VILLALTA

Our File: PB 3965 0101

March 15, 1988

Project Scope Revision for
Villalta Gold Project

KLOHN LEONOFF LTD. CONSULTING ENGINEERS	PROJECT VILLALTA HEAP LEACH GOLD		
	TITLE LOCATION AND PROJECT LAYOUT		
CLIENT: CANAMIN RESOURCES LTD.	DATE OF ISSUE March 15/88 APPROVED J. Bove	PROJECT No. PB 3965 01	DWG. No. B-1001

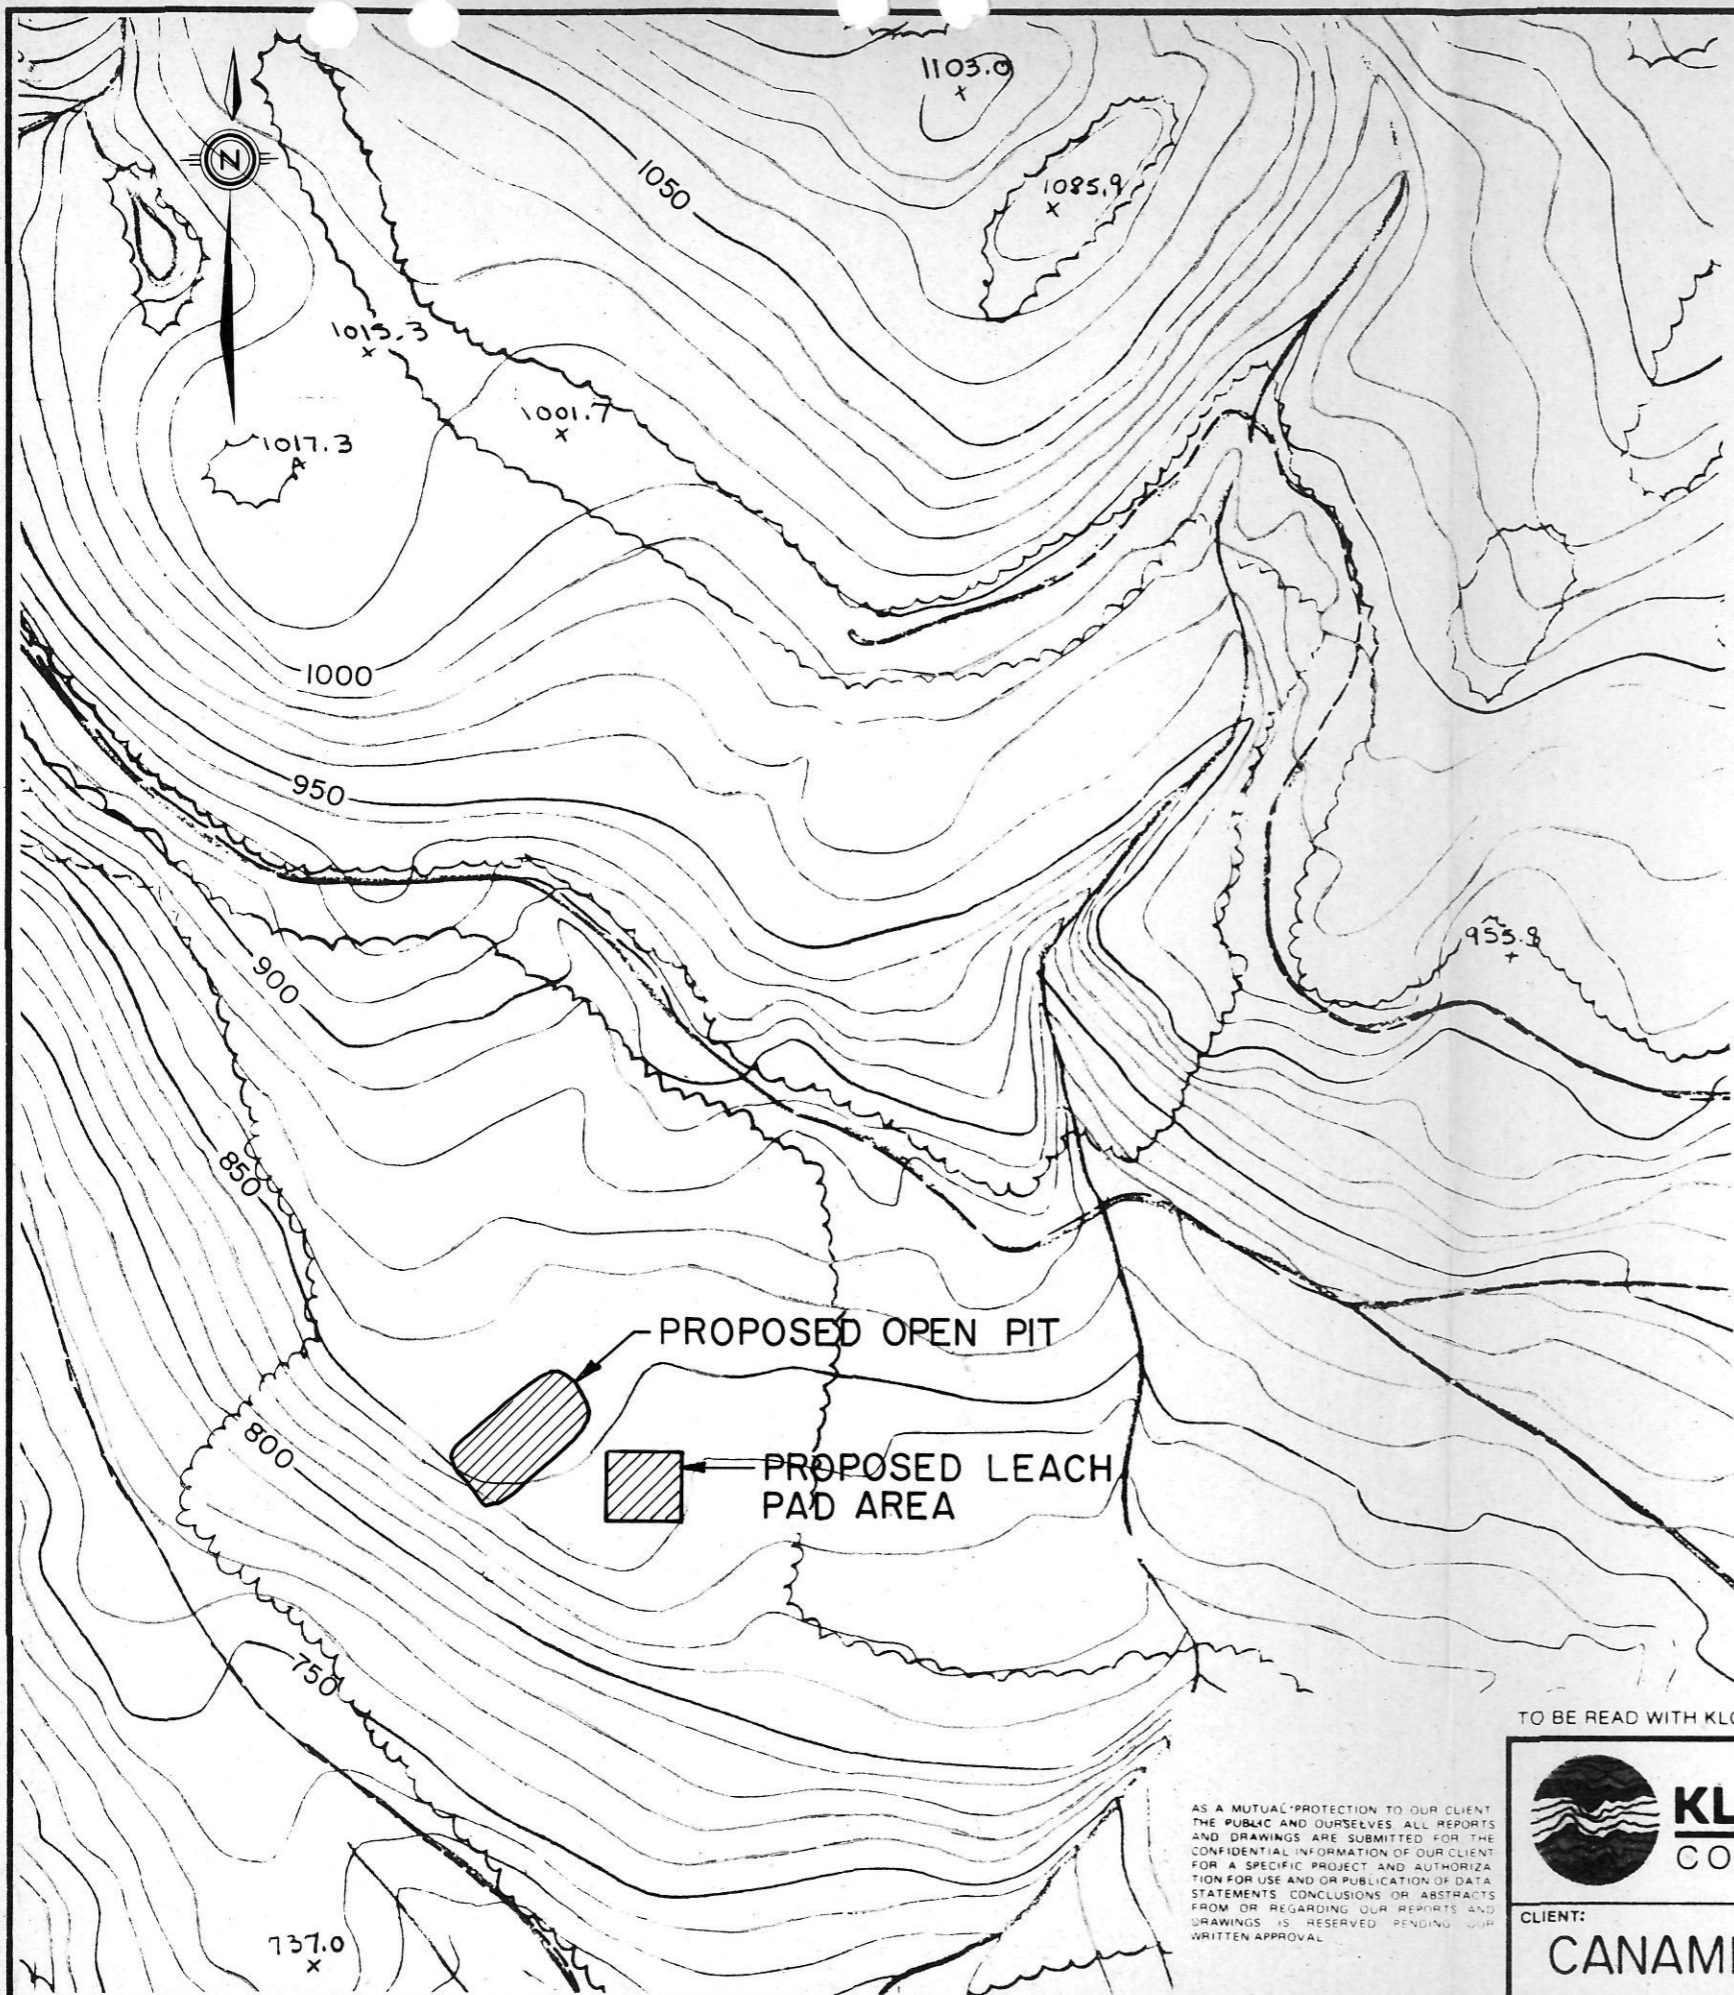
appropriate authorities at this time. A brief description of the project follows. Previous location drawings were provided in the original prospectus and have not been reproduced here. A drawing with detailed topography and a proposed project layout is included here as Drawing B-1001.

The leach pad is expected to cover an area of approximately 40 m square. The pad will be constructed on a relatively flat area a short distance from the pit. The relative locations of the pit and leach pad are shown on Drawing B-1001. The foundation will be shaped using glacial till or other borrow material. A liner system using a combination of glacial till and geomembranes will be designed to collect pregnant solutions and prevent leakage to the environment. The project will be designed so

Baseline water quality testing is proposed for four surface sites upstream and downstream of the project area. Two will be located on the headwaters of the Nanaimo River. Two will be located on an unnamed tributary creek southeast of the site. The proposed sampling locations will be located as shown on Drawing B-1001.
